Service Recall Bulletin - 96S48 Supplement #1

To: All FCSD Regional Managers
cc: All Regional Sales Managers
Ford and Lincoln-Mercury Divisions
All PDC Managers
Subject: Safety Recall 96S48 Supplement #1 - Left Side Inspection
Procedure added to Technical Instructions

TO: All Ford and Lincoln/Mercury Dealers October, 1997
SUBJECT: Safety Recall 96S48 Supplement #1 - Left Side Inspection Procedure
added to Technical Instructions

1990-92 PROBE PASSIVE RESTRAINT (MOTORIZED) SEAT BELT SYSTEM
 REPLACEMENT OF LEFT SIDE RAIL (96S48) –
 INSPECTION/REPLACEMENT OF RIGHT SIDE (96S99)

FIGURE 1

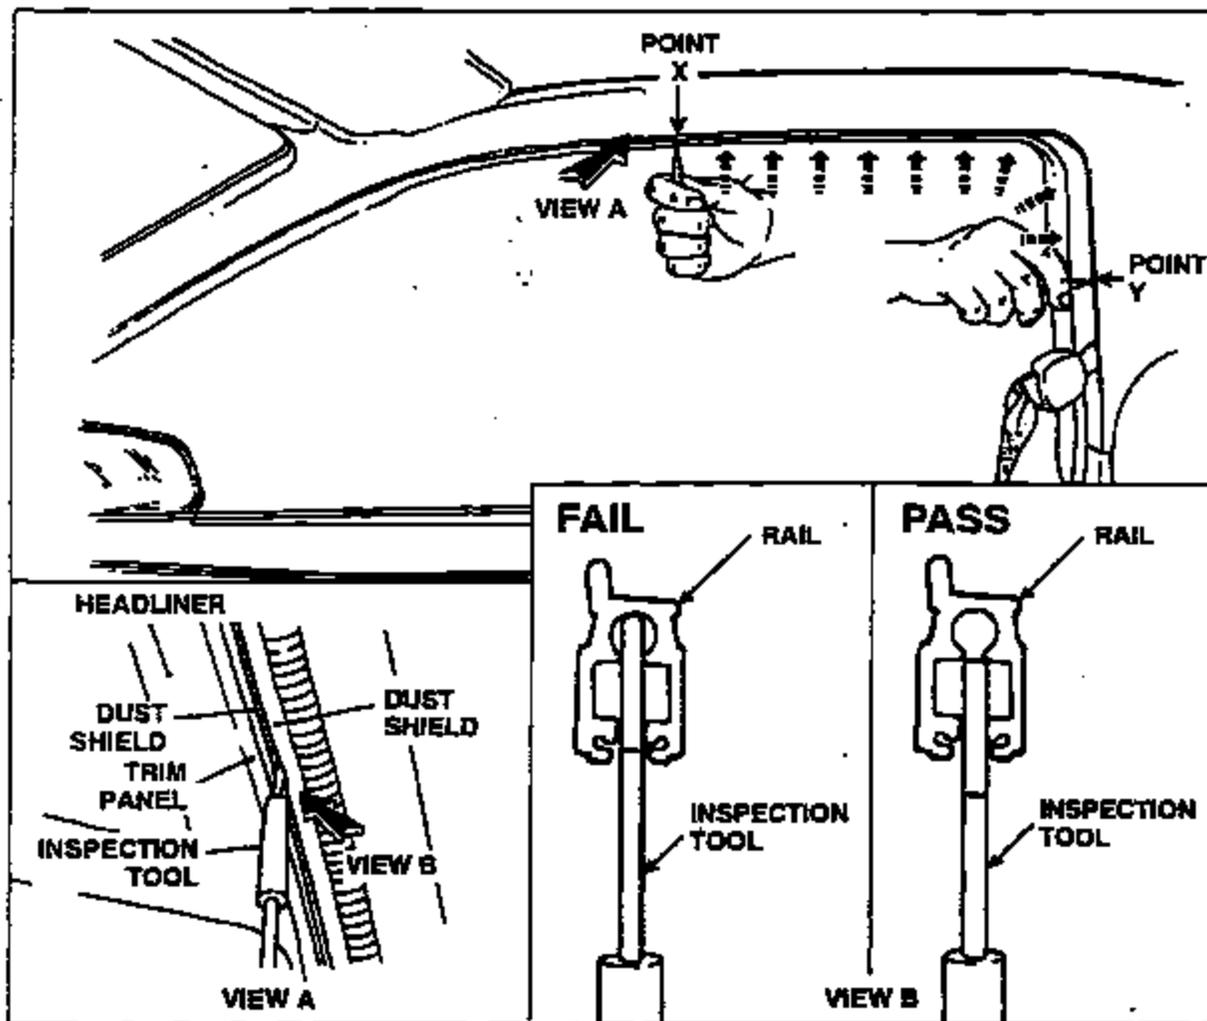
Insert the inspection tool between dust shields of the rail assembly at point X. Tool must be installed until it bottoms out in the rail assembly. Note the distance between the dust shields and the scribed line on the tool. Insert the inspection tool every 1/2" from point X to point Y of the rail assembly. See Figure 1. **DO NOT SLIDE THE INSPECTION TOOL ALONG THE RAIL ASSEMBLY. REMOVE AND REINSERT EVERY 1/2" BETWEEN POINT X AND POINT Y.**

- If installed inspection tools' depth *does not increase* (scribe line *does not* move closer to the dust shield) anywhere between points X and Y, no service action is required.
- If installed inspection tools' depth *increases* (scribe line *moves closer* to the dust shield) anywhere between point X and Y, the rail assembly must be replaced. Go to Page 4 for Rail Replacement.
